Shoreline Park Plans, dated September 2016

Brooklyn Basin Shoreline Park

Revisions to FDP Design

September 26, 2016

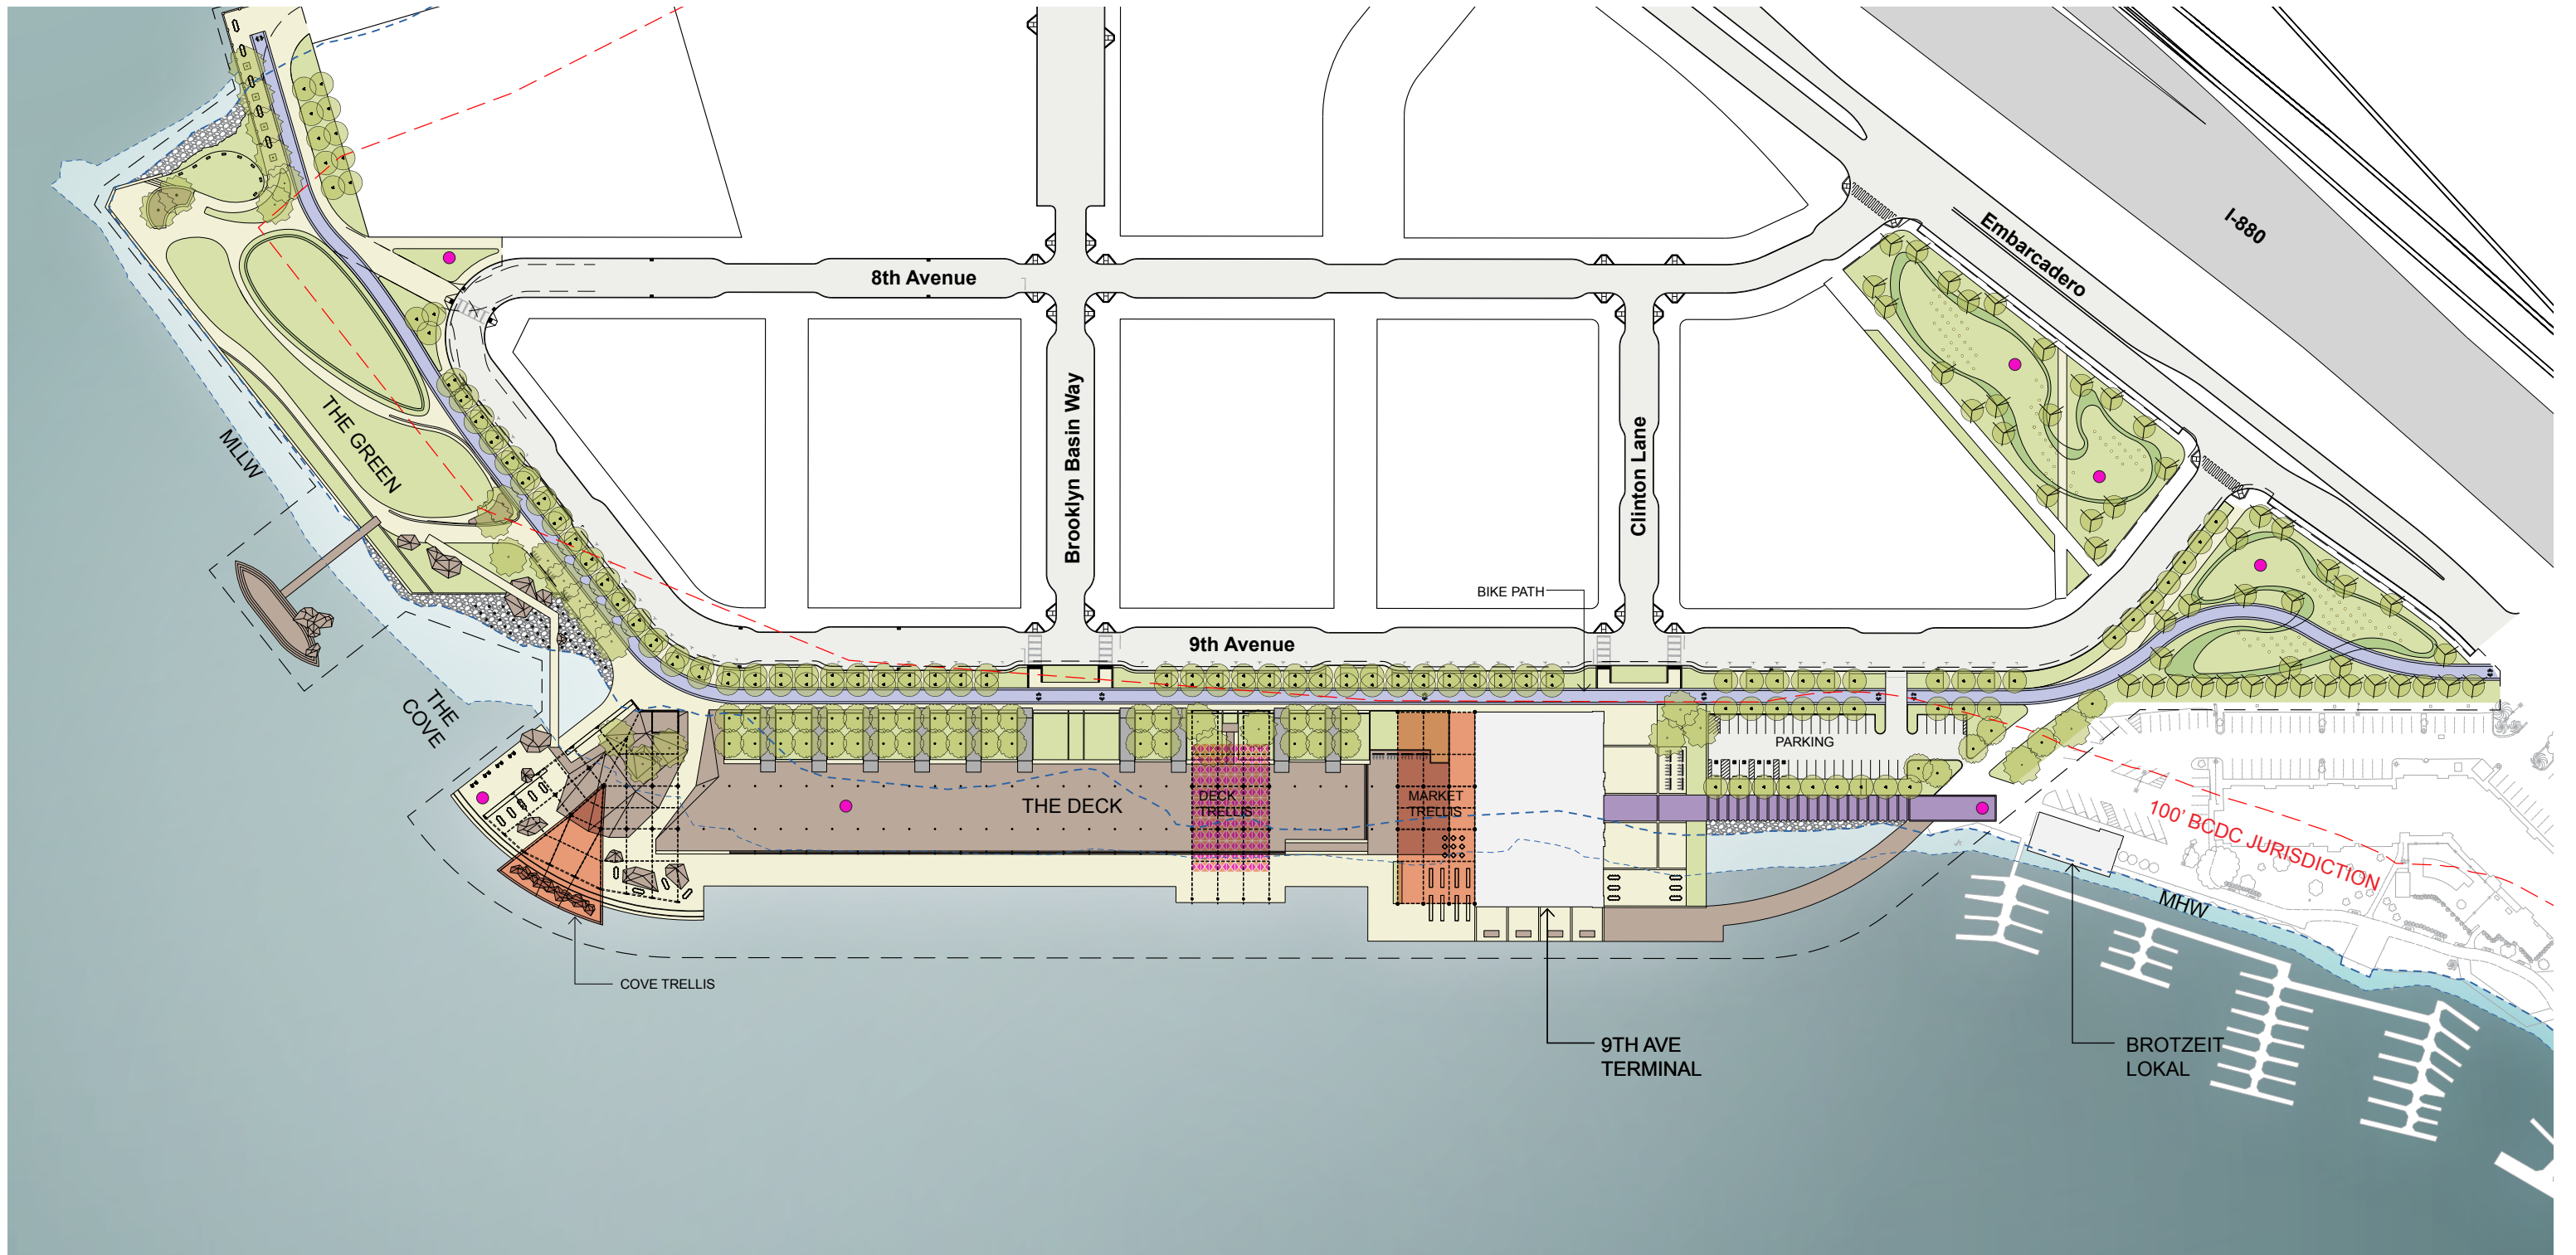
- Expanded to be on both sides of 9th Avenue
- Increased Storm Water Treatment Area to handle wharf run off
- Increased total number of trees
- Re-aligned bike path to circulate across the bioswale instead of adjacent to it
- Re-located the fairy lights from the estuary waters into the bioswales

- Expanded the total interior space of the Terminal from 4 bays to 5 bays

- Removed fairy lights from the Estuary
- Increased number of trees

- Removed terracing below surface of existing wharf
- Added hill with ADA access under trusses
- Added canopy suspended from truss to frame performance space
- Increased planting
- Expanded and relocated floating deck area
- Reconfigured near water trail to promote better low tide experience
- Removed fairy lights from Estuary
- Relocated existing piles to remain to be above MHHW

- Removed the incline grade change to comply with 8th Avenue view corridor
- Changed name to “The Green”
- Increased level flexible lawn area
- Increased storm water treatment to handle Wharf Run-Off

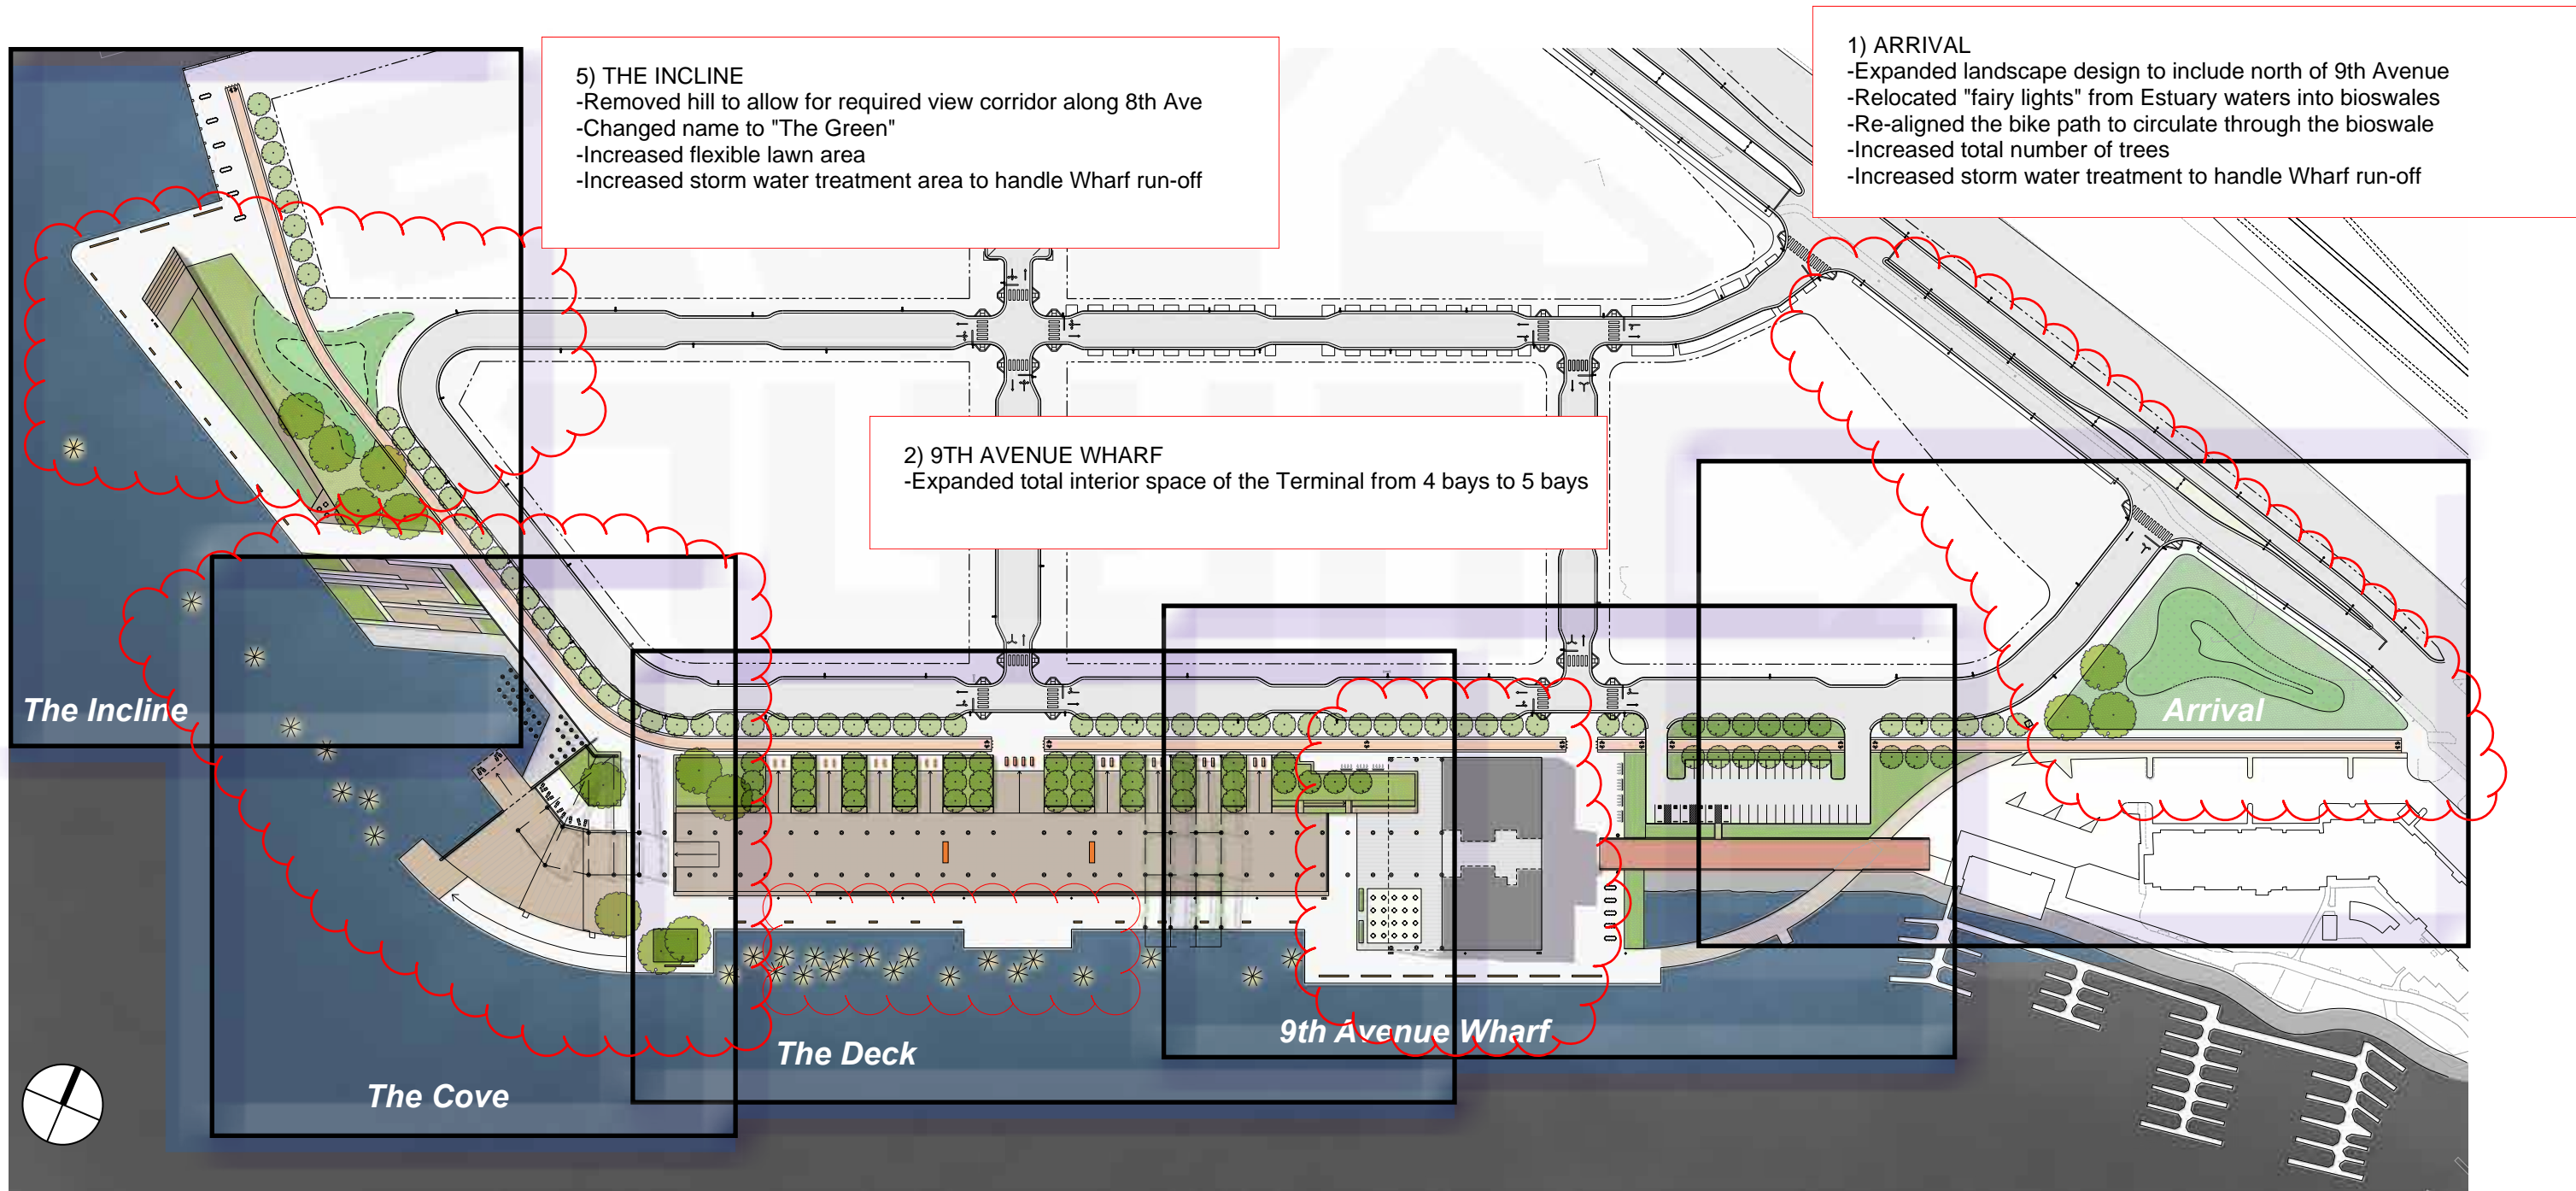
5) THE INCLINE
 -Removed hill to allow for required view corridor along 8th Ave
 -Changed name to "The Green"
 -Increased flexible lawn area
 -Increased storm water treatment area to handle Wharf run-off

1) ARRIVAL
 -Expanded landscape design to include north of 9th Avenue
 -Relocated "fairy lights" from Estuary waters into bioswales
 -Re-aligned the bike path to circulate through the bioswale
 -Increased total number of trees
 -Increased storm water treatment to handle Wharf run-off

2) 9TH AVENUE WHARF
 -Expanded total interior space of the Terminal from 4 bays to 5 bays

4) THE COVE
 -Removed terracing below wharf finish surface
 -Added "Hill" under trusses
 -Added Canopy suspended from truss to frame performance space
 -Increased planting
 -Expanded floating deck area
 -Reconfigured near water trail to promote better low tide experience
 -Removed "fairy lights"
 -Relocated (e) piles to remain to all be above MHHW

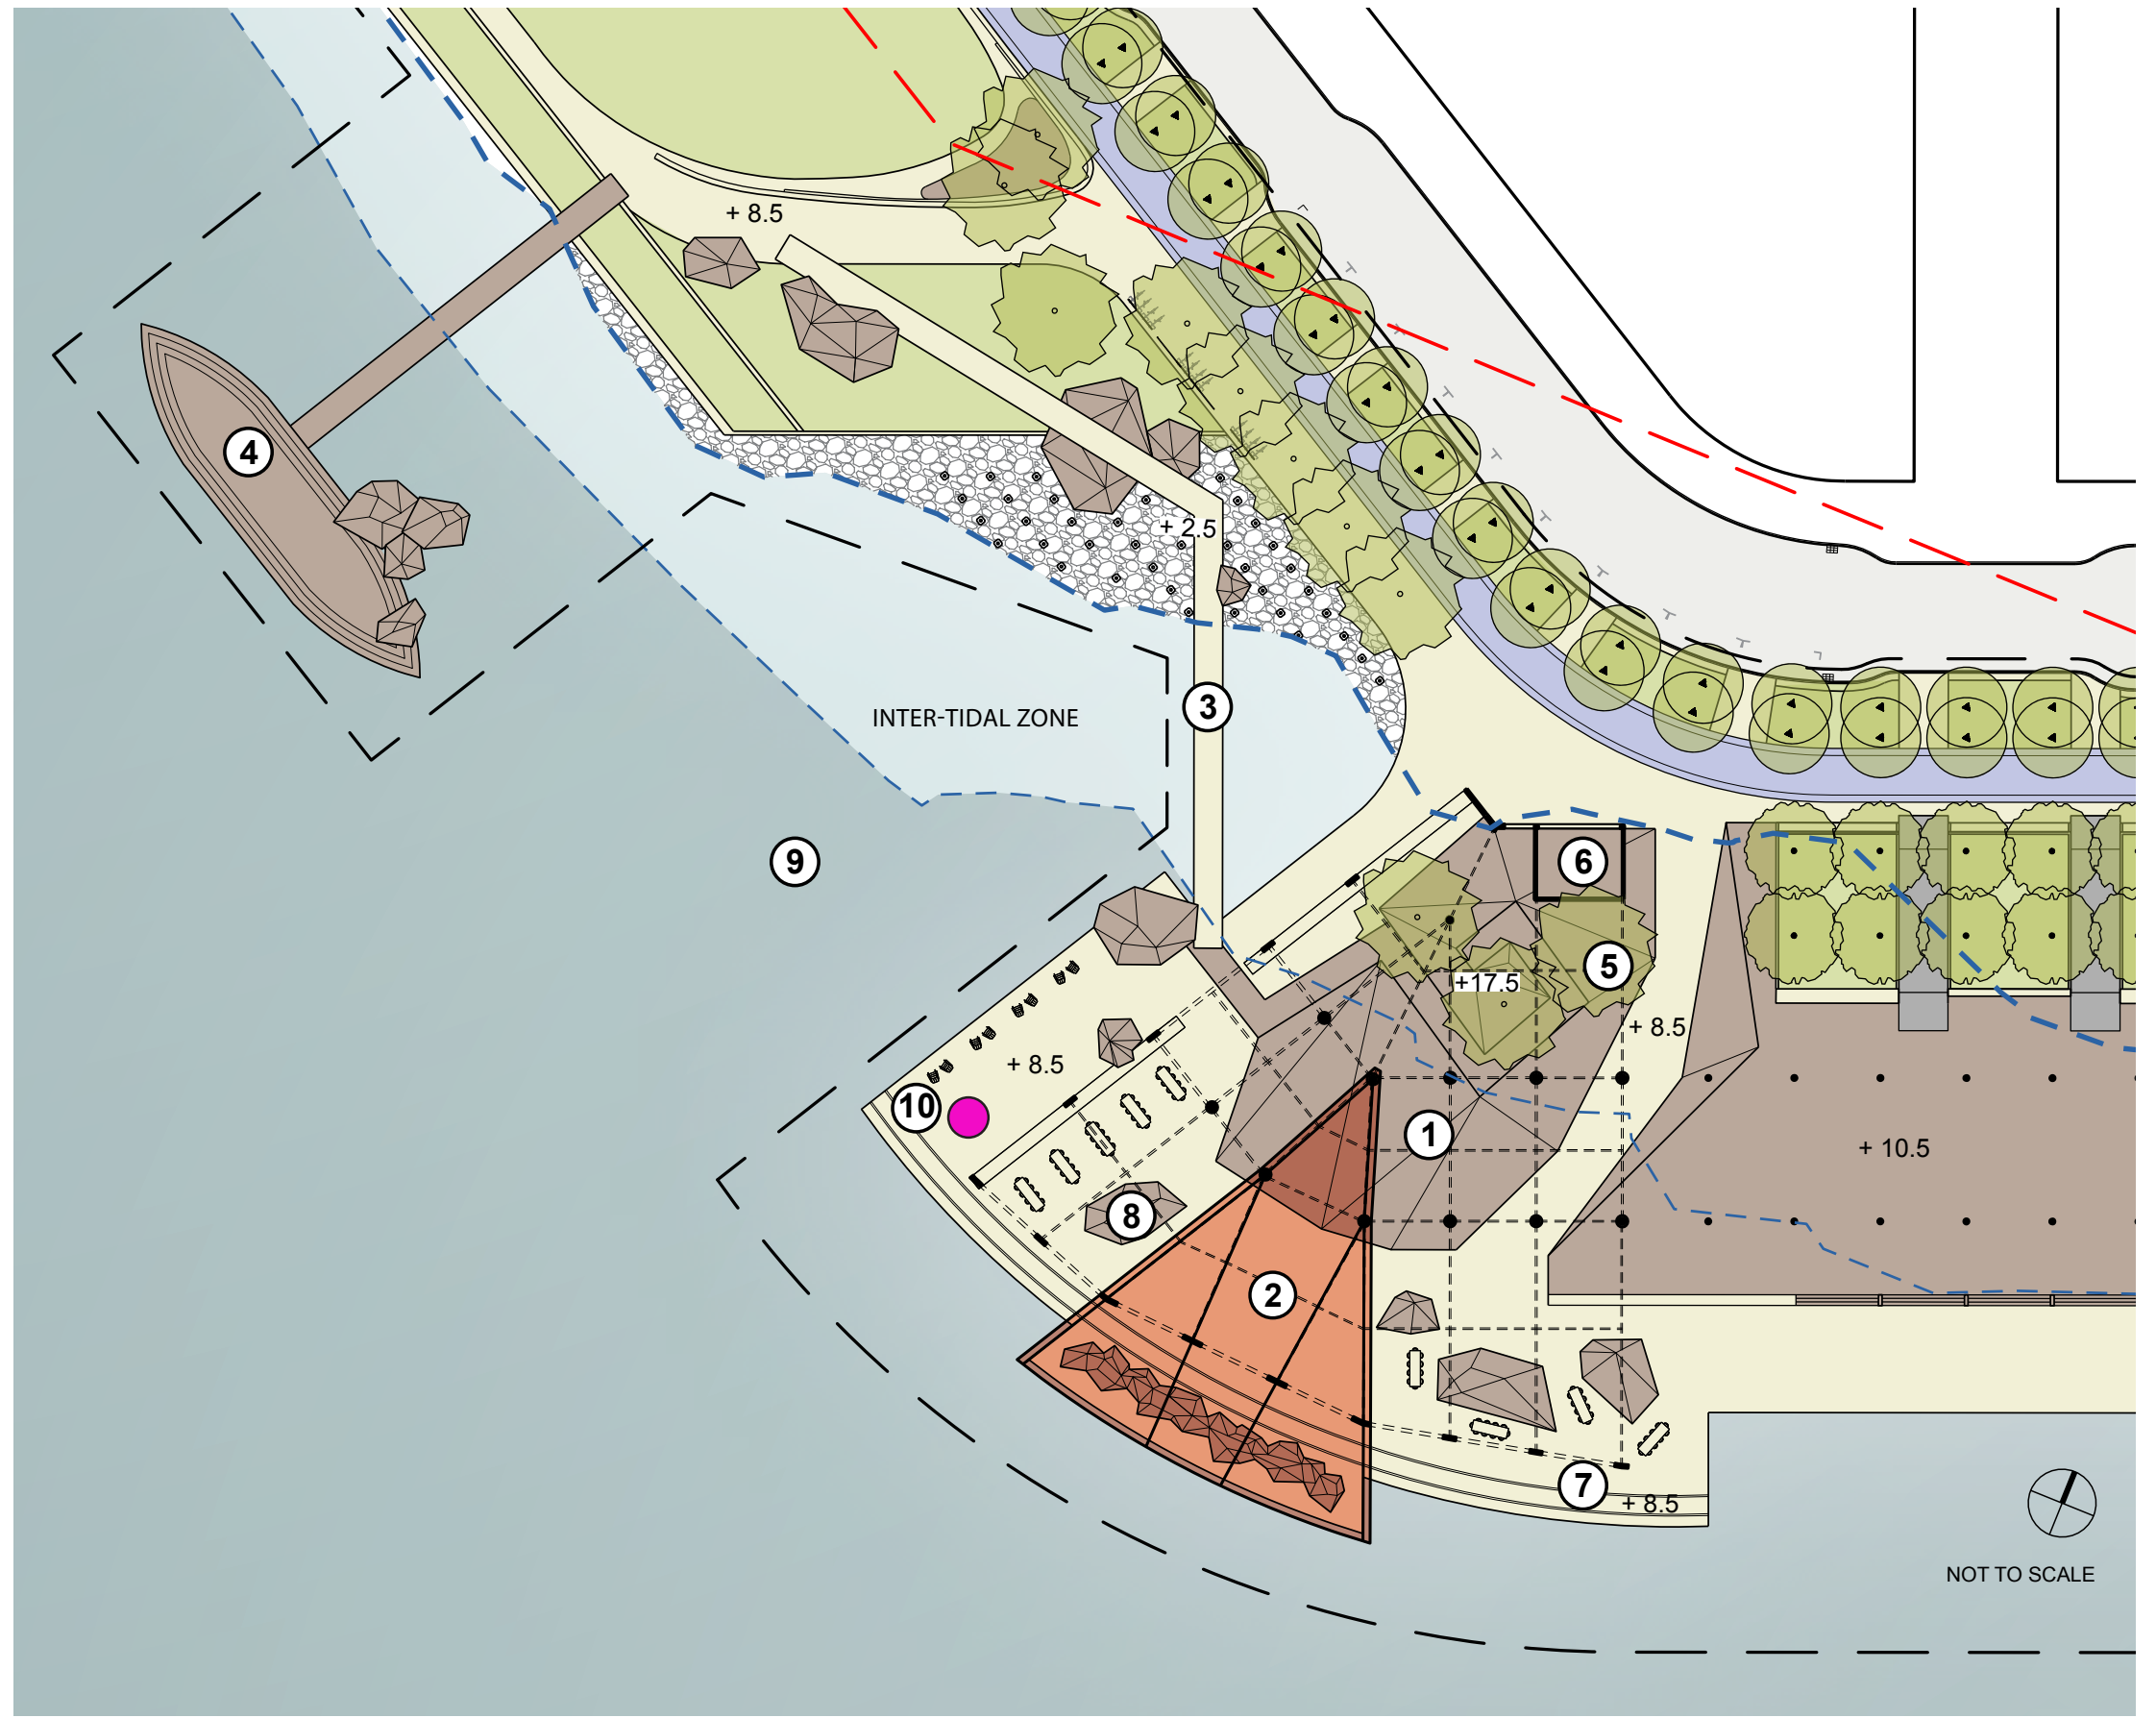
3) THE DECK
 -Increased number of trees
 -Removed "fairy lights" from the Bay
